Planning Board Recommendation Alpine Trails Subdivision

Planning Board Recommendation

A: Trail Concept Recommended for Conditional Approval

ALPINE TRAILS SUBDIVISION
PRELIMINARY PLAT
SEC. 35, T.17 N., R.15 W., P.M.M.,
MISSOULA COUNTY, MONTANA

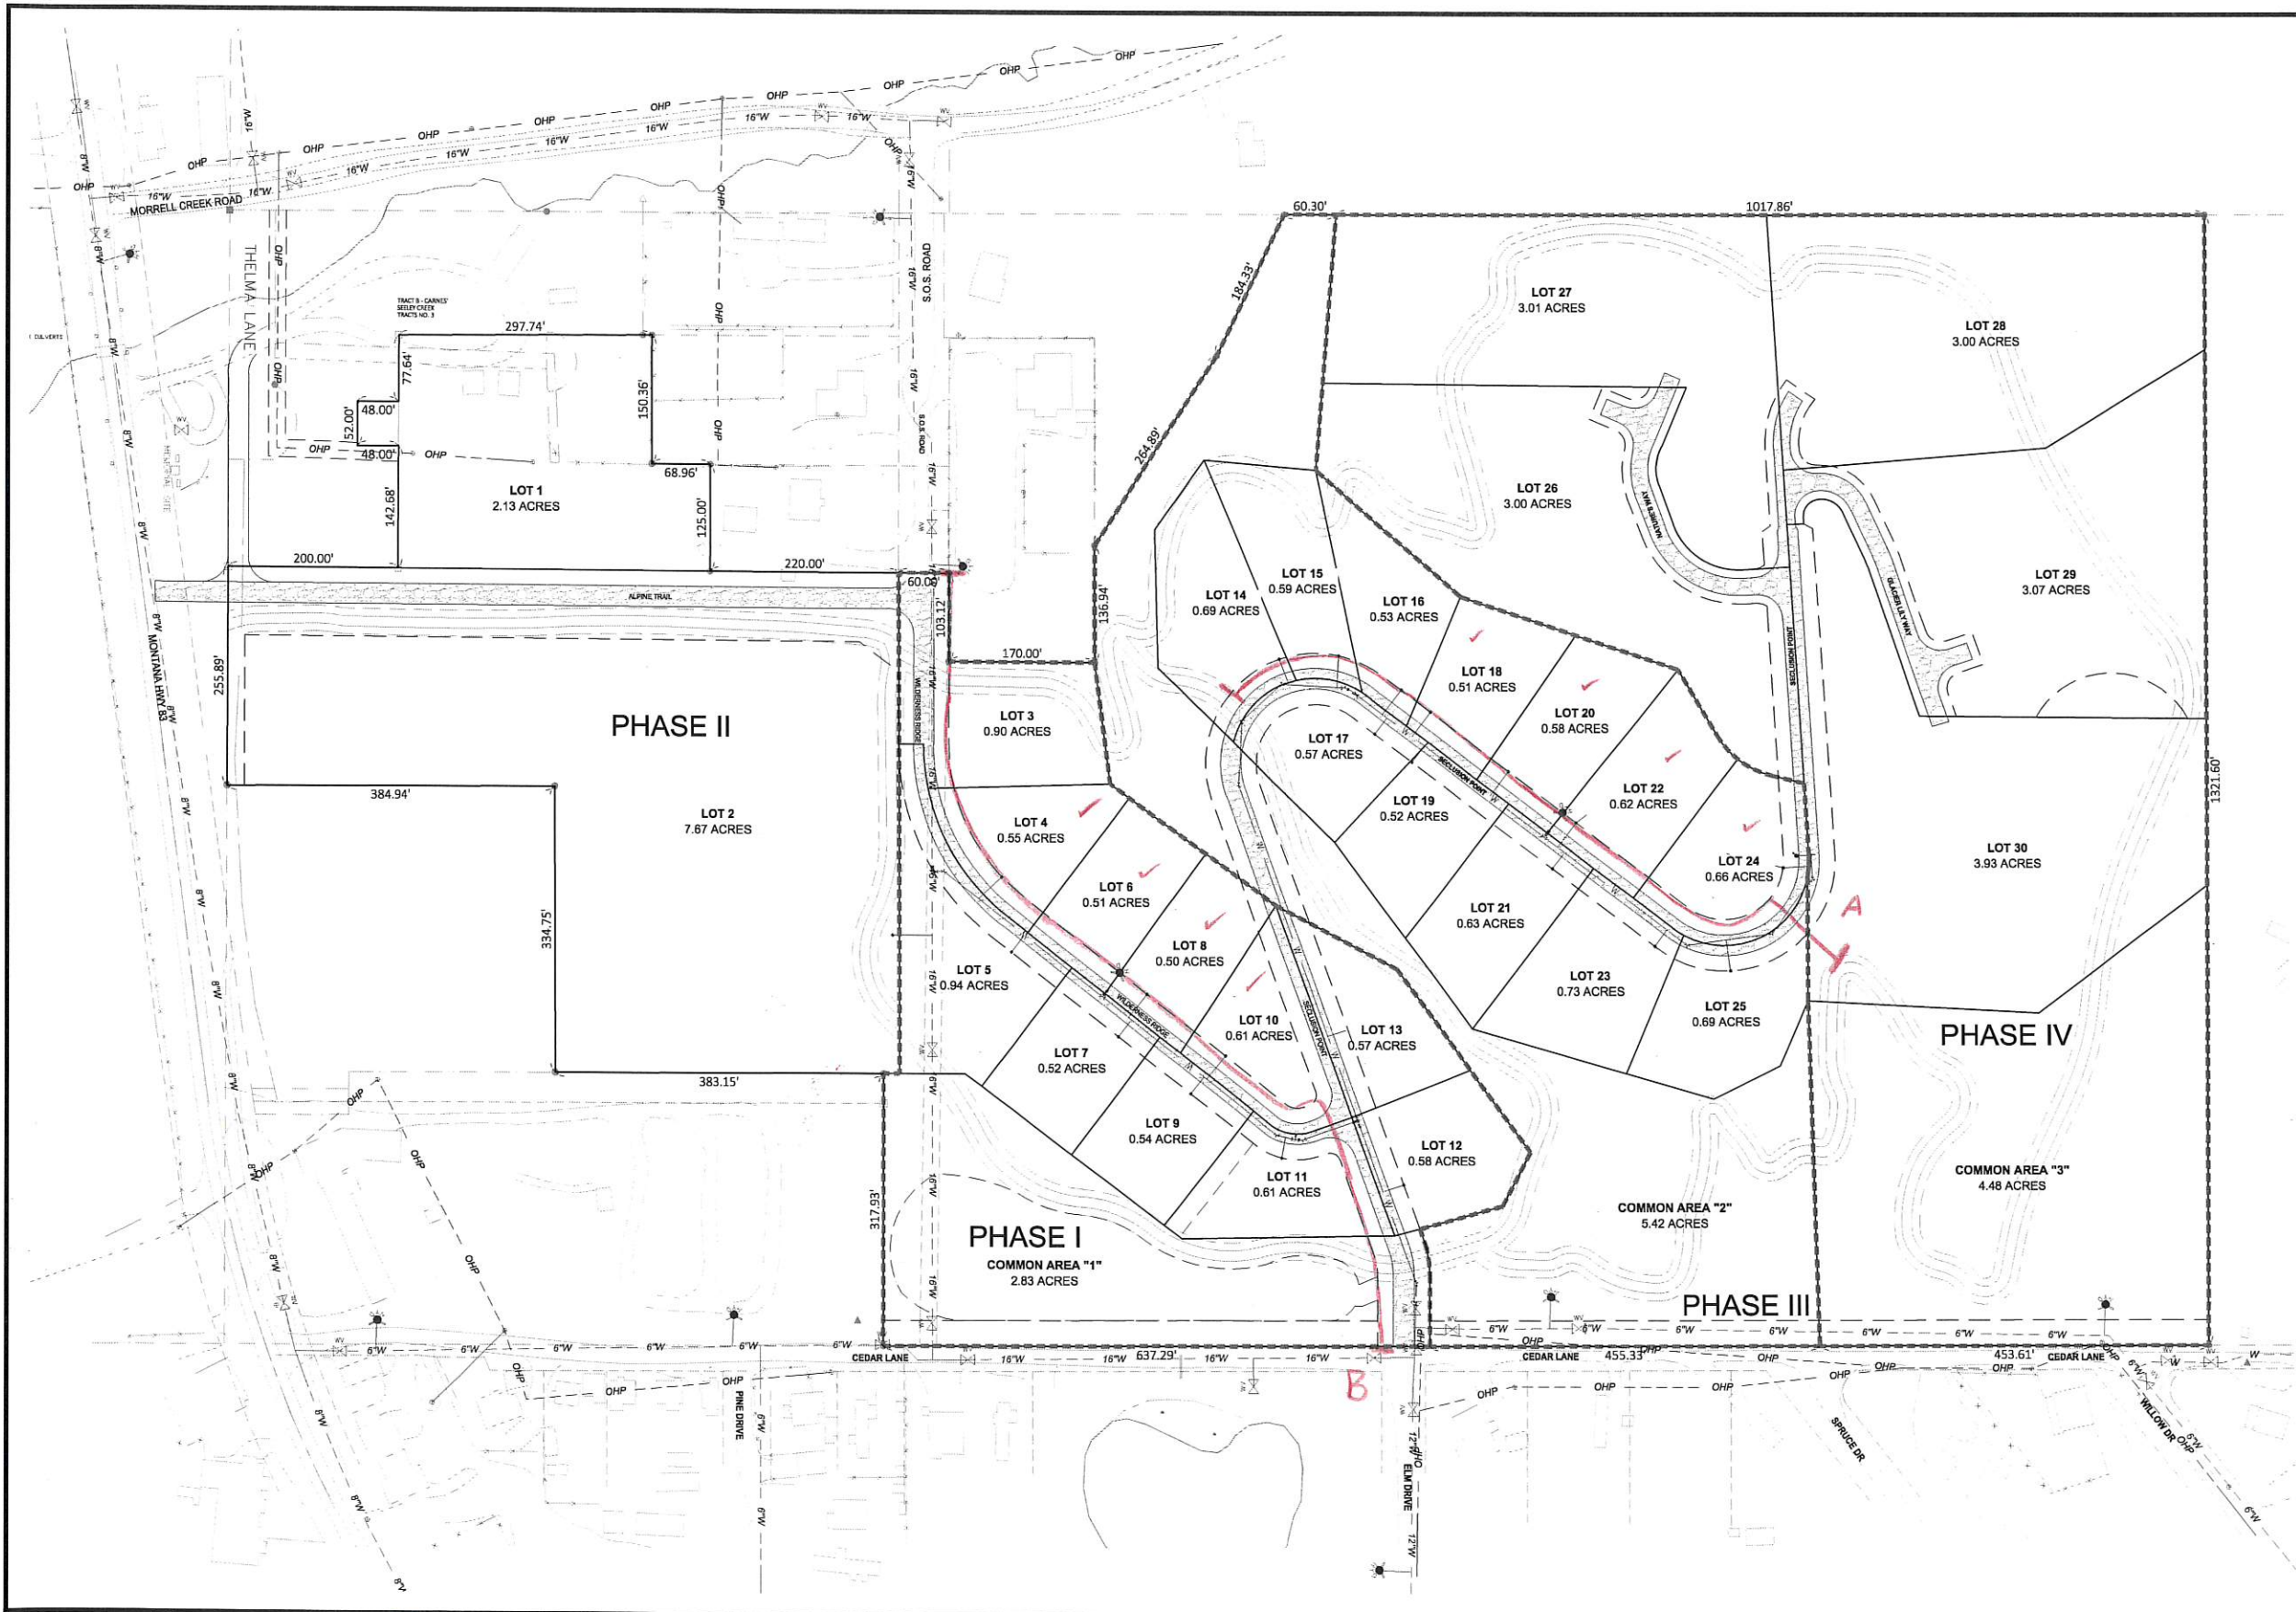
At the meeting, the applicant's representative expressed a preference for approval of the variance, adding that alternatively, they would prefer conditional approval of the variance so as to provide only two segments of trail along internal roads, one from S.O.S. Road to the intersection of Cedar Lane and Seclusion Point, and another from the trail connection on Lot 14 to the trail connection on Lot 25. This concept was recommended by County Parks, Trails and Open Lands on December 22, 2016 during the second of three rounds of agency comment. An exhibit of that concept is included with this summary (Attachment A).

The Board discussed this concept, the different purposes of a recreation trail and a transportation trail, and whether the surface type would be a continuation of the recreation natural surface trail (grass) or a type compliant with the standard in Section 3.4.9.5, requiring "concrete or an asphalt surface or a comparable surface material that is durable, maintainable, and usable in year round weather conditions." It was determined that a compliant surface type would be required. Additional discussion of whether standards from the Americans with Disabilities Act (ADA) should be applied at this site due to the private roads and topography included information that ADA permits reasonable and substantial accommodations given the topographic constraints along the road, the Subdivision Regulations requirement for trail compliance with ADA standards in Section 3.4.9.3.B, and clarification that the recreation trail would not be required to comply.

Motions to make the following amendments to condition of approval #17 and strike condition of approval #18 were unanimously approved.

17. Plans for and installation of a 5' wide paved trail in accordance with the Subdivision Regulations along the sections of road as approved in the variance internal to the subdivision shall be reviewed and approved by County Public Works and CAPS prior to final plat approval. (*Subdivision Regulations Section 3.4.9.2.B.1*)
- ~~18. Plans for the 5' wide paved trail shall include public non-motorized access easements along the three portions of trail that 1) enters the subdivision from Cedar Lane, 2) extends along Seclusion Point, 3) and continues west along Wilderness Ridge and Alpine Trail, subject to review and approval by County Public Works and CAPS prior to final plat approval. The trail may be included within an appropriate private access easement for all other areas within the subdivision. (*Subdivision Regulations Section 3.4.9.3.A*)~~
